**STATE OF TENNESSEE  
DEPARTMENT OF TRANSPORTATION  
DESIGN DIVISION**

**INSTRUCTIONAL BULLETIN NO. 13-08**

**Regarding New and Revised Standard Drawings**

**Effective for the July 12<sup>th</sup> letting (May 1<sup>st</sup> turn-in),** the following Standard Drawings are new or revised and Section V of the Design Guidelines is revised for this update.

MARKING DETAIL  
FOR  
EXPRESSWAY & FREEWAY  
INTERCHANGES

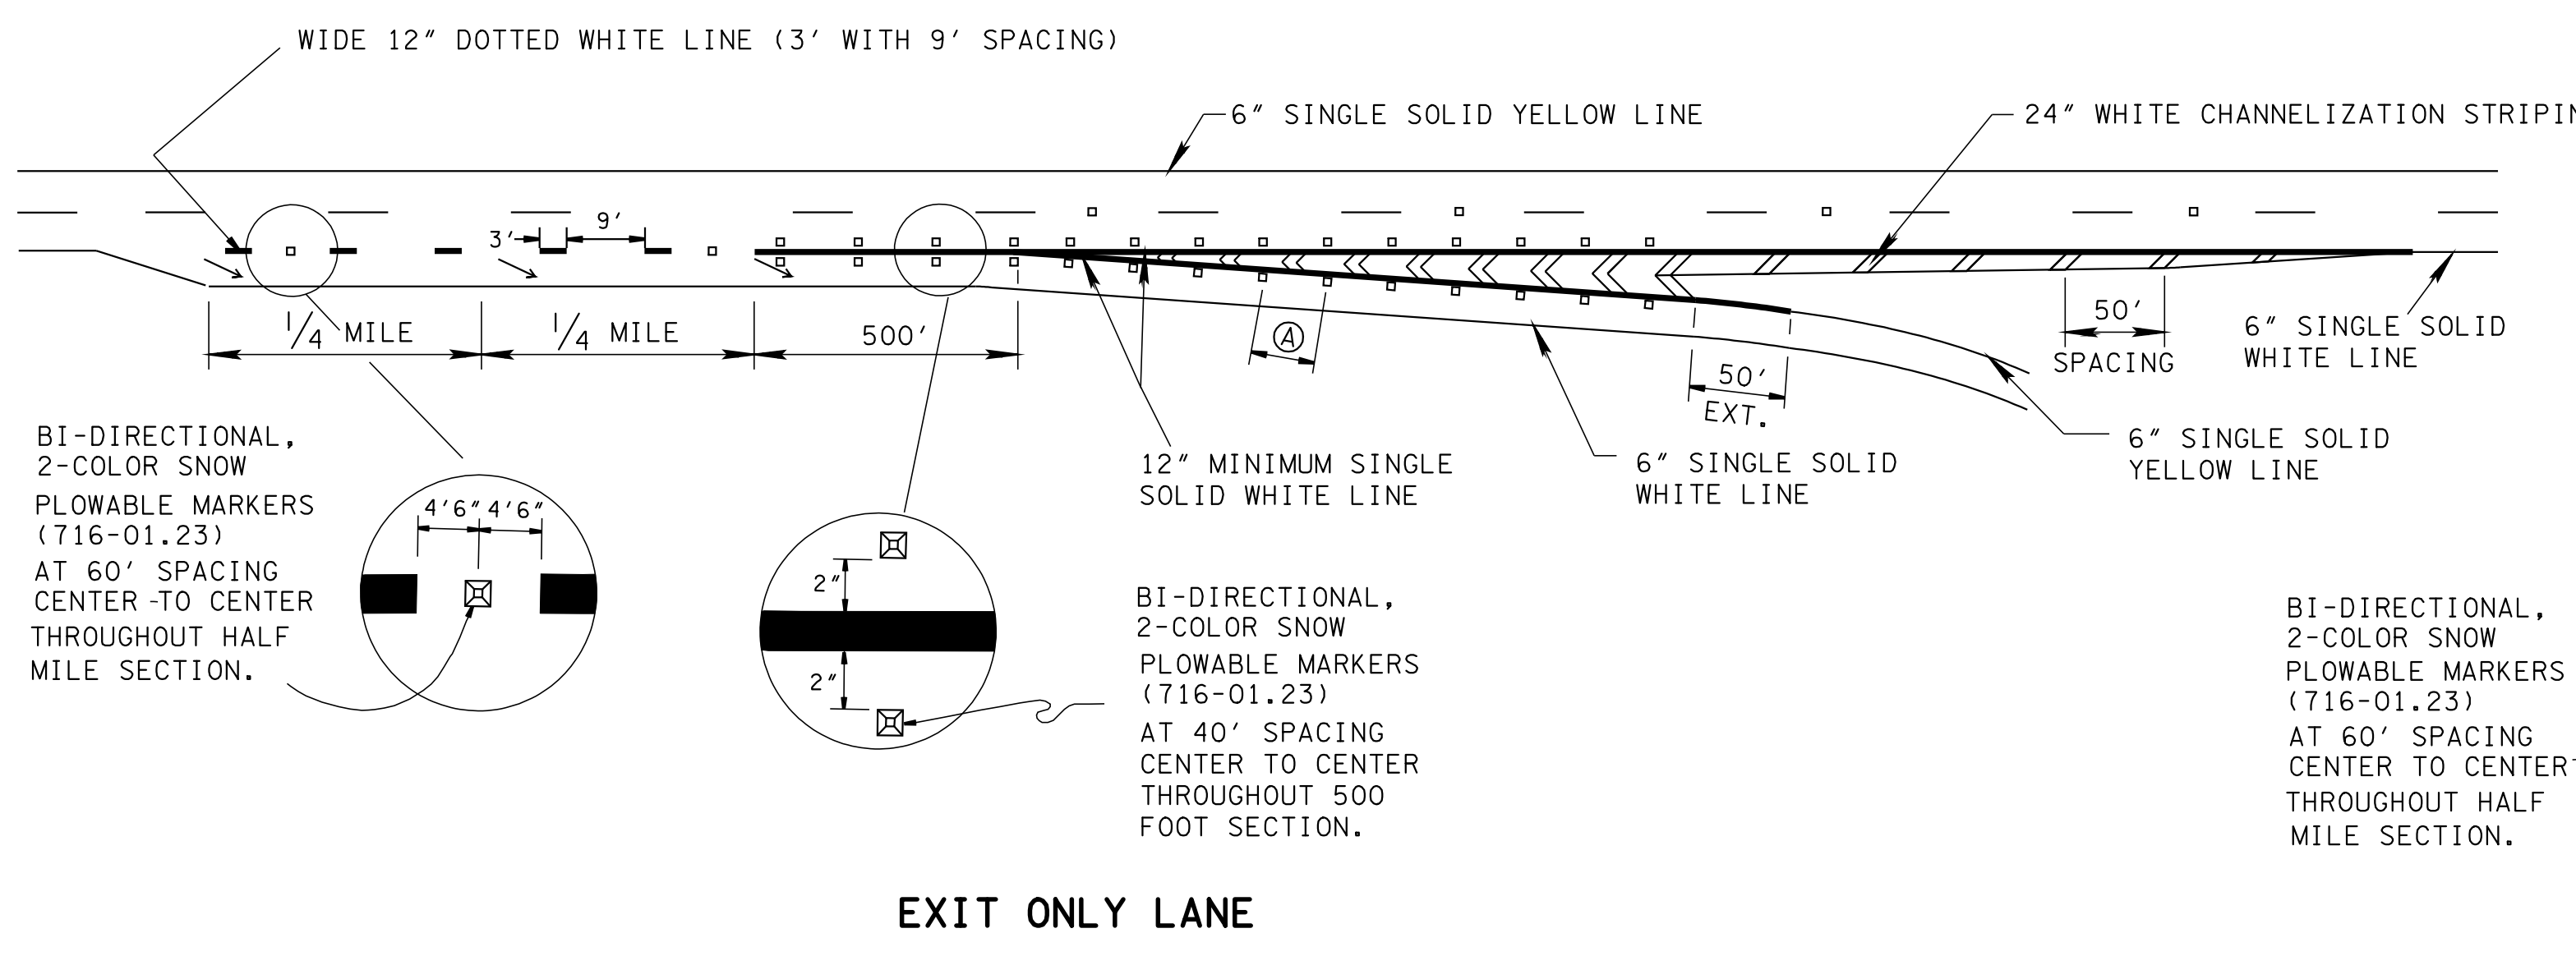
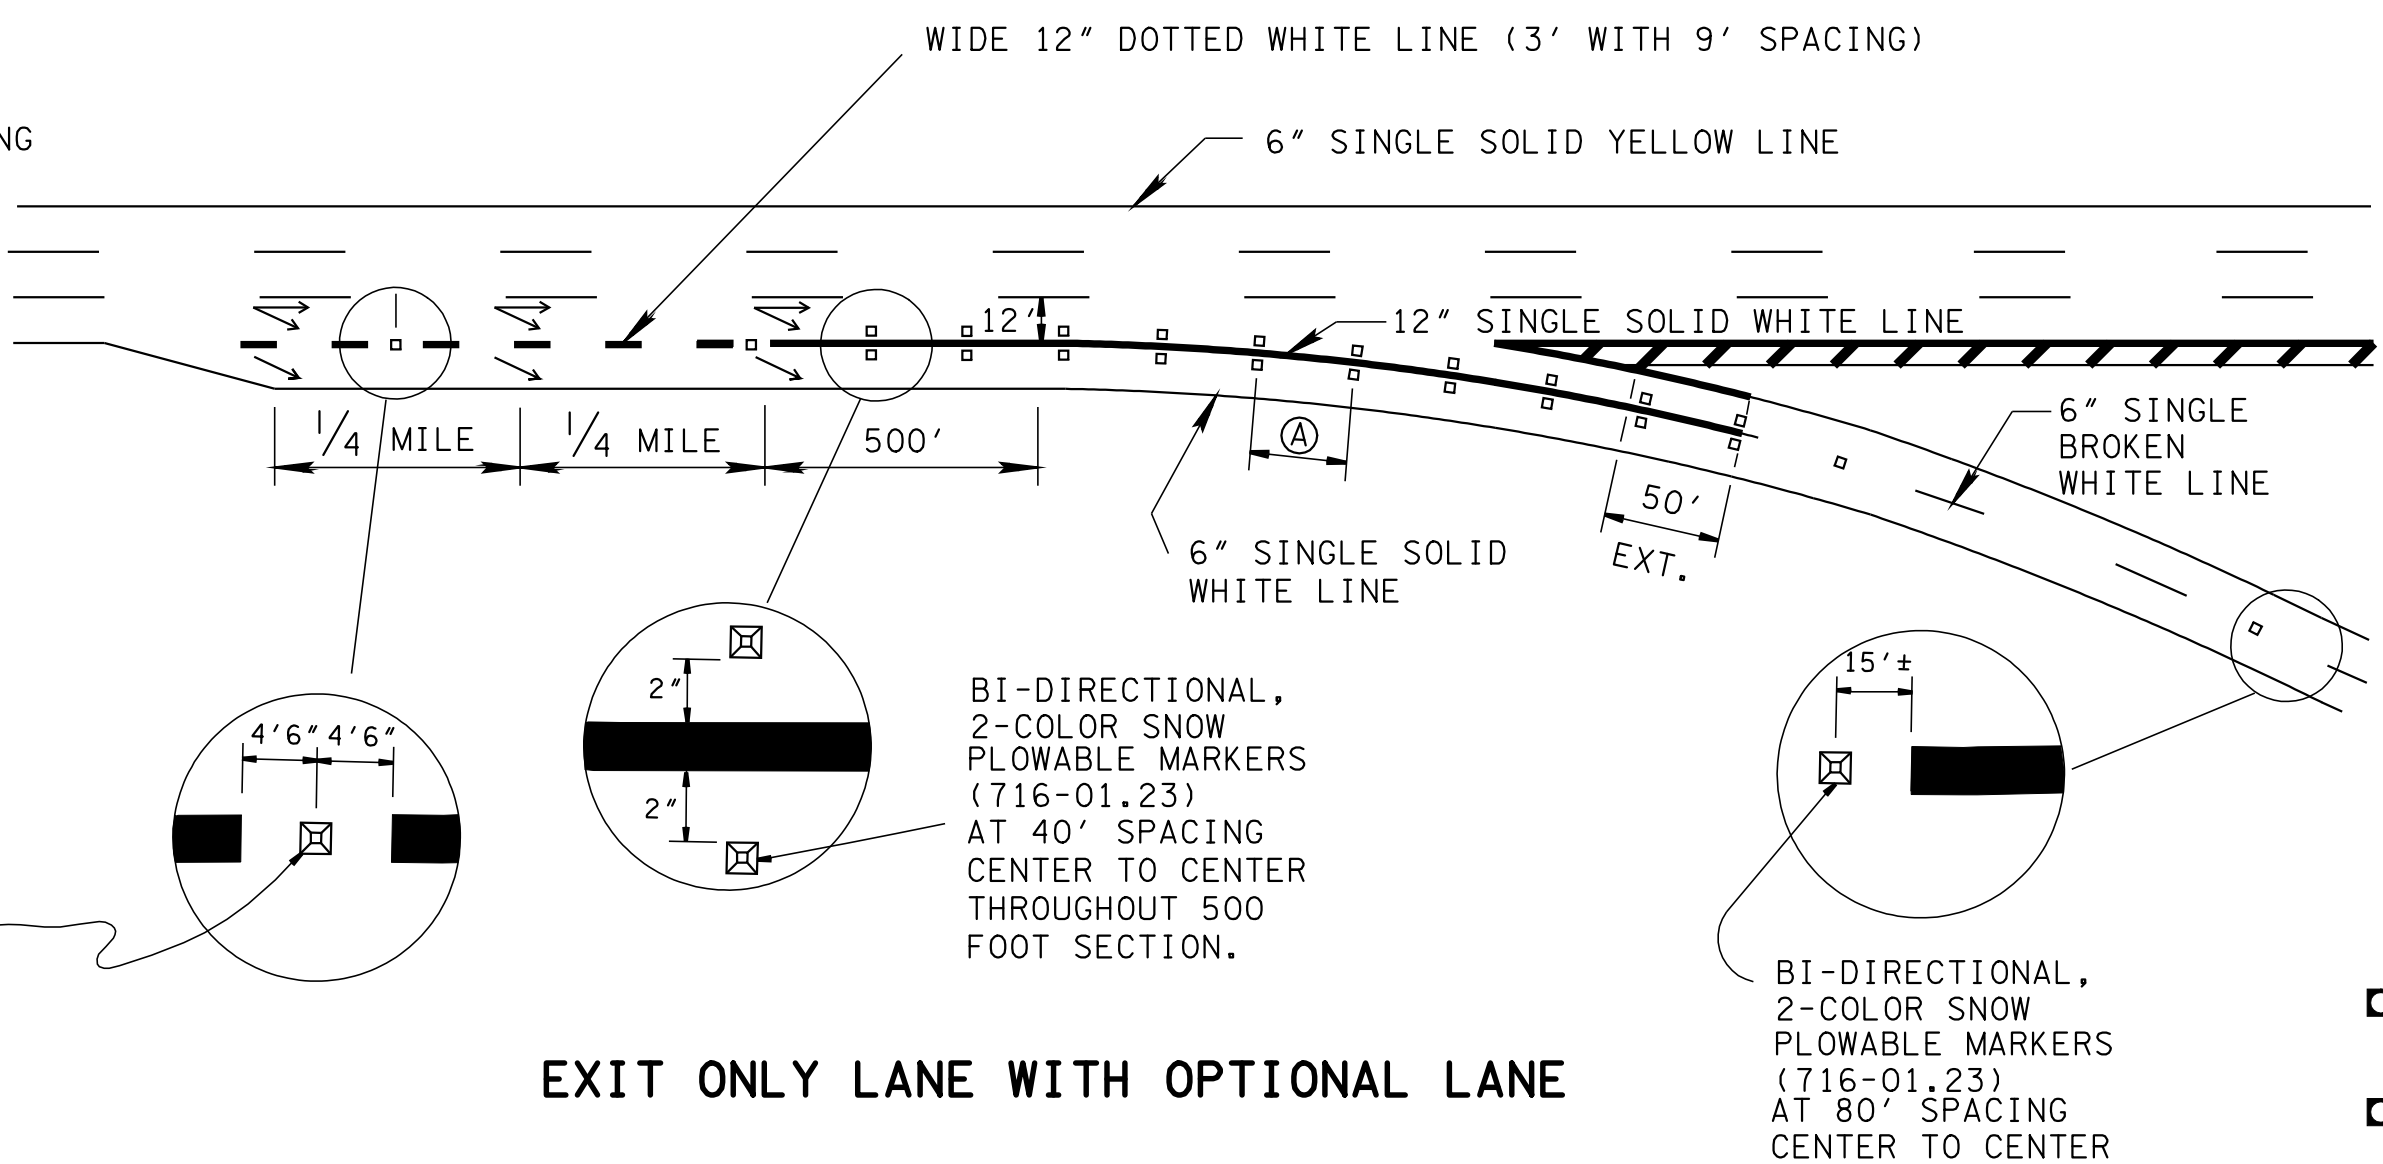
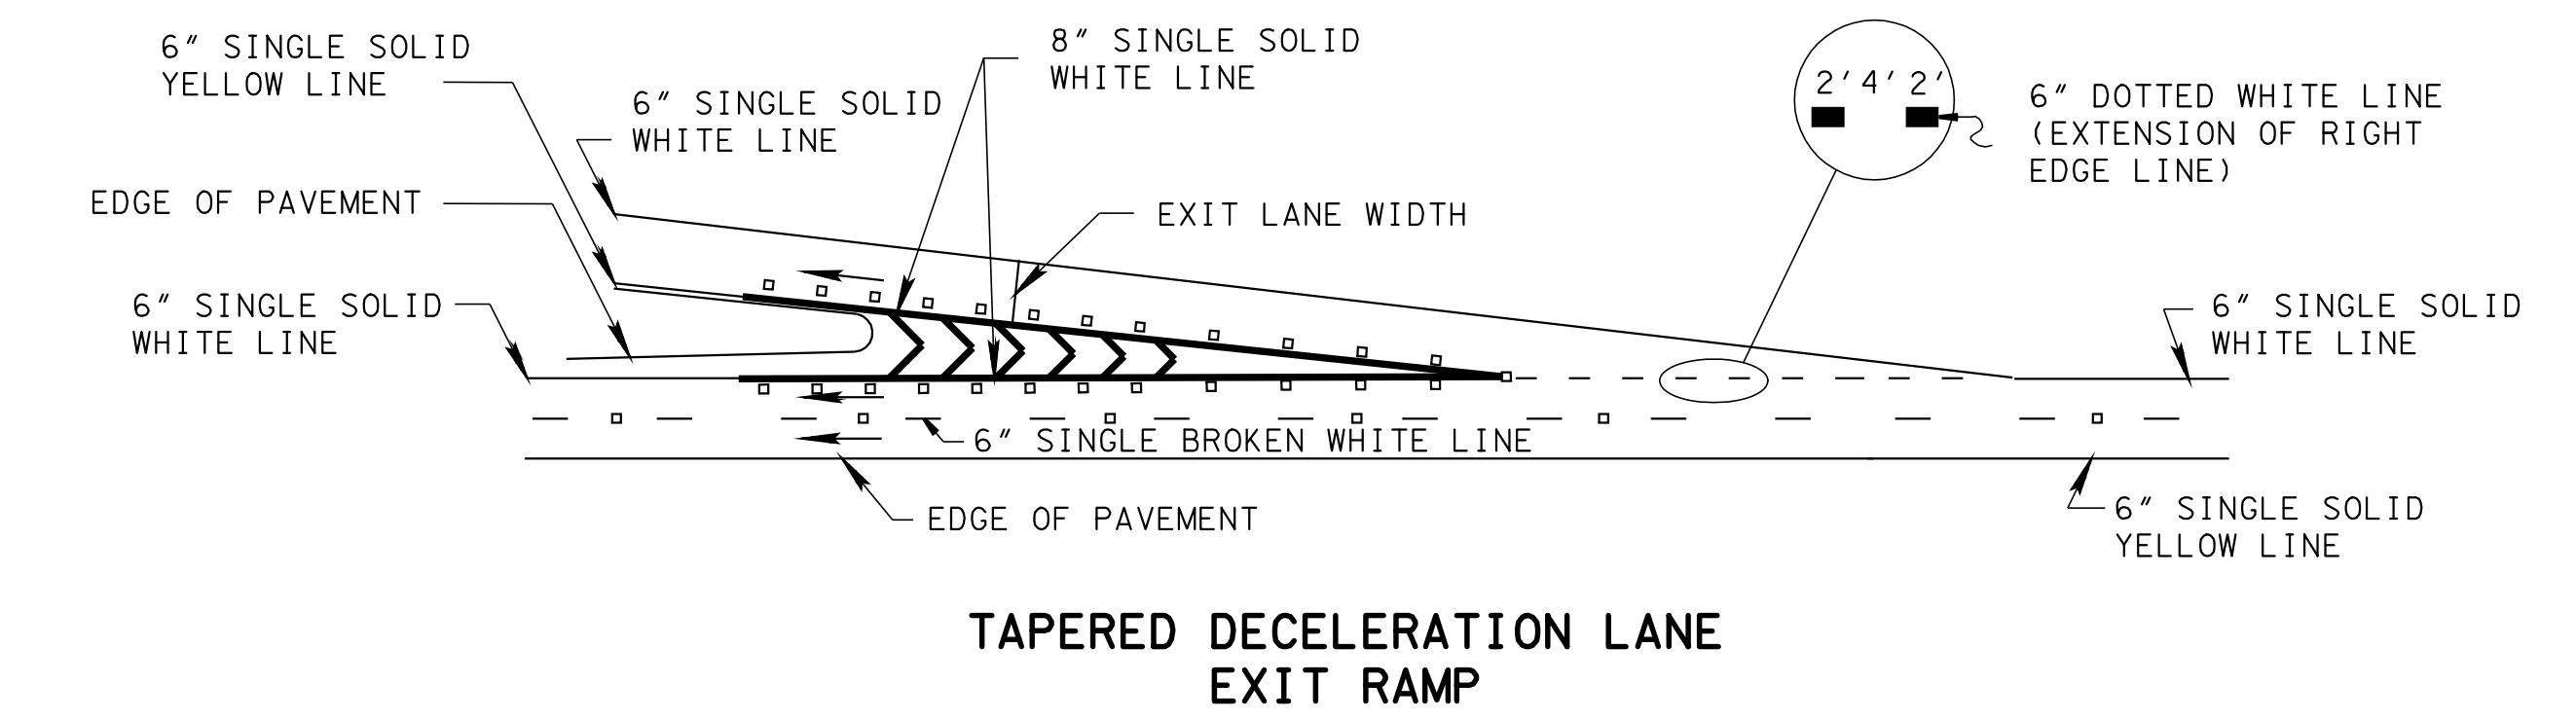
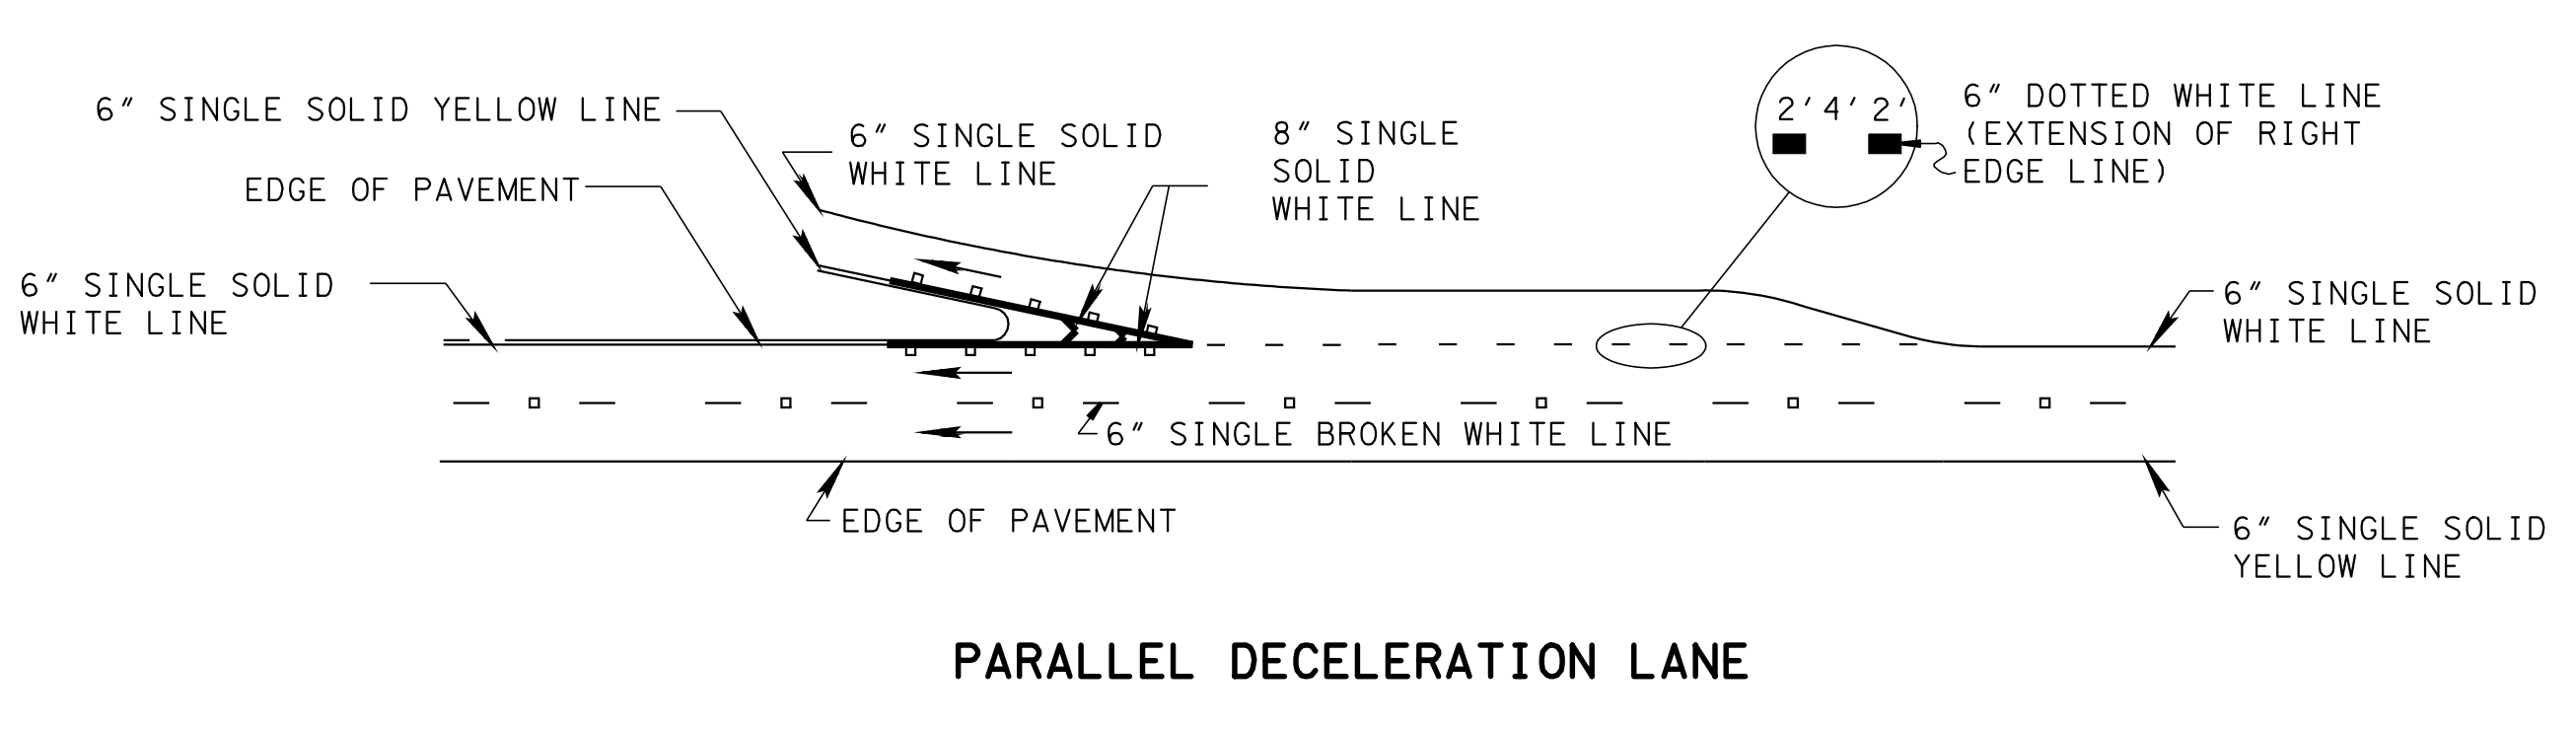
REV. 5-24-12: REVISED PAVEMENT MARKINGS FOR TAPERED ENTRANCE AND EXIT AND PARALLEL ENTRANCE AND EXIT RAMP.

REV. 6-22-12: REVISED SPACING FOR SNOW PLOWABLE MARKINGS IN EXIT ONLY DETAILS.
